ZONING CHANGE REVIEW SHEET

CASE: C14-2010-0015 (The Domain Rezoning-Endeavor) **P. C. DATE:** August 10, 2010

MEMORANDUM

SUBJECT: C14-2010-0015 (Endeavor Domain)

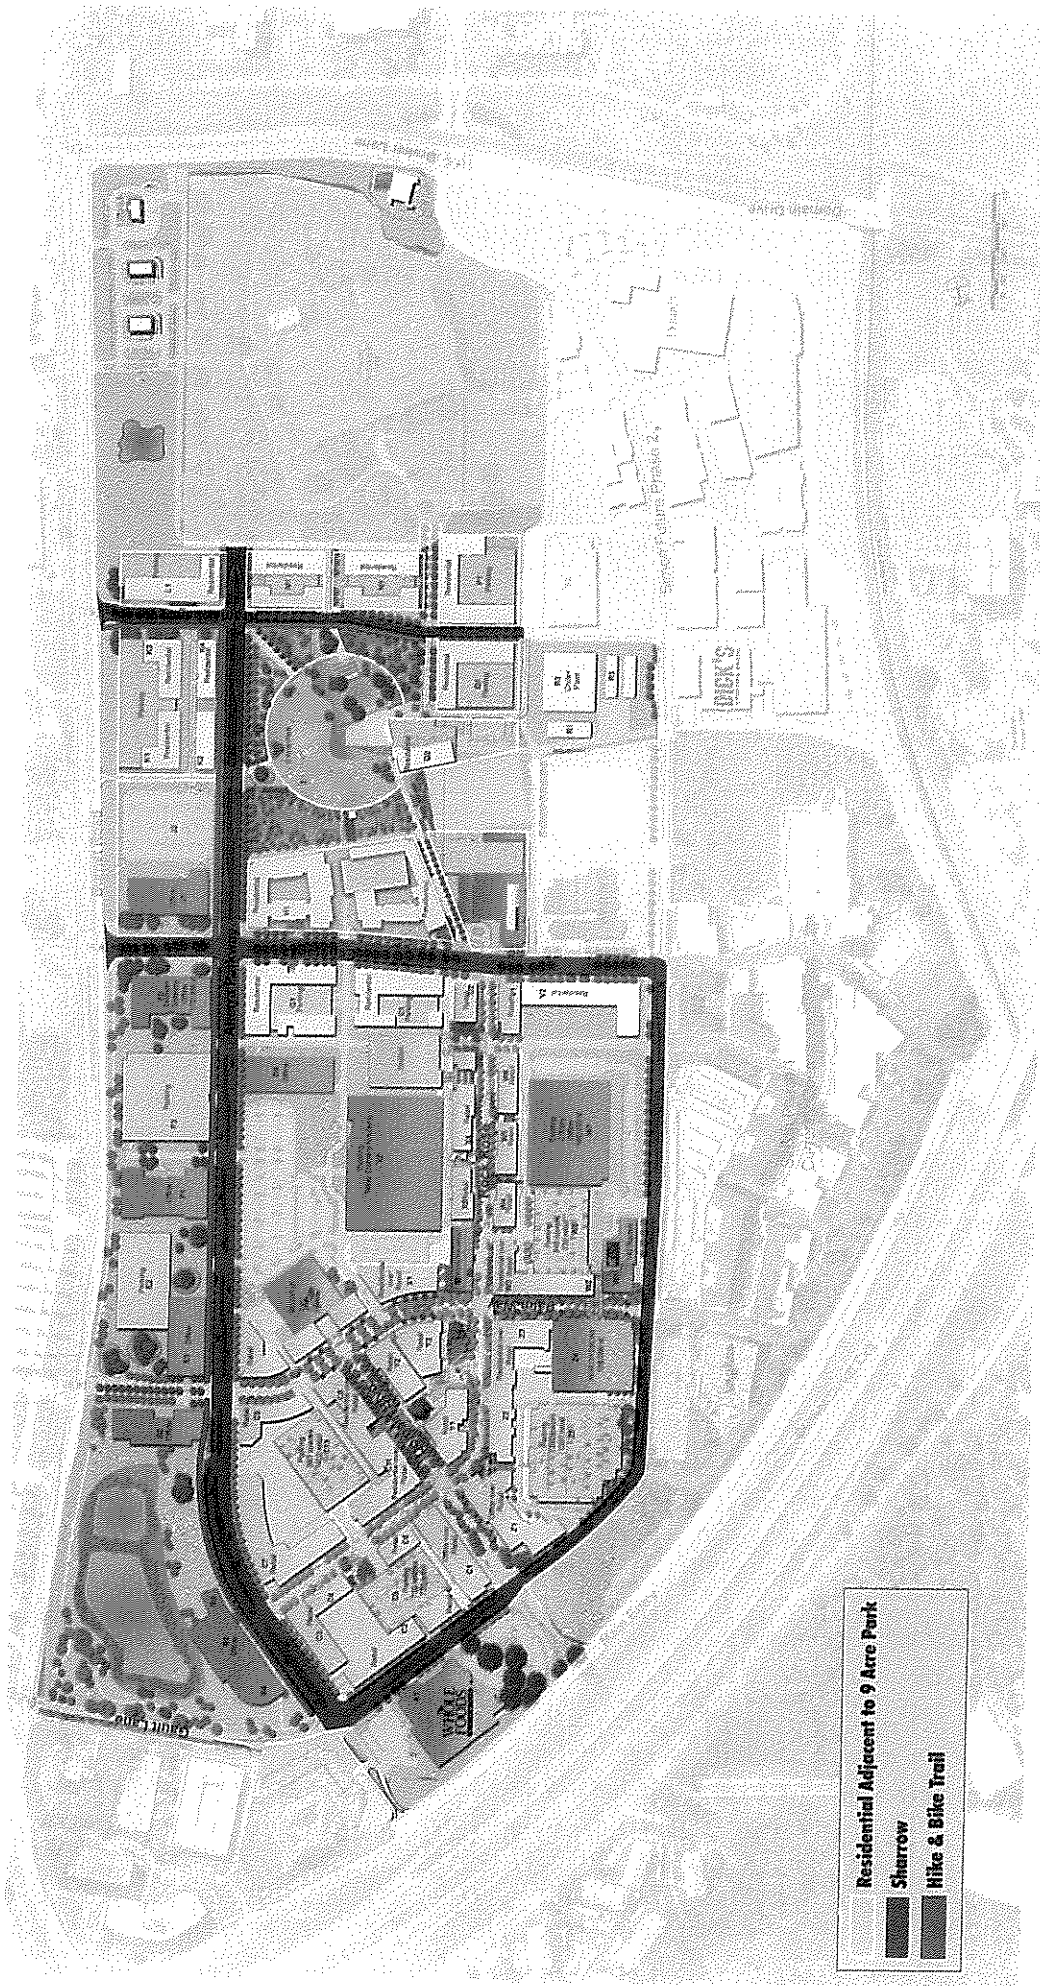
2. The exhibit originally provided by the applicant should be updated to remove sharrows from Rock Rose Ave. and add sharrows to the following streets:

- Domain Drive between Alterra and Domain Blvd.,
- Domain Drive between Domain Blvd. to Esperanza on the east side of the street only
(note: it's our assumption that Endeavor has control over the east side of the street only).
- Esperanza between Alterra Parkway and Burnet Road, and
- Kramer Lane extending to the western property line.
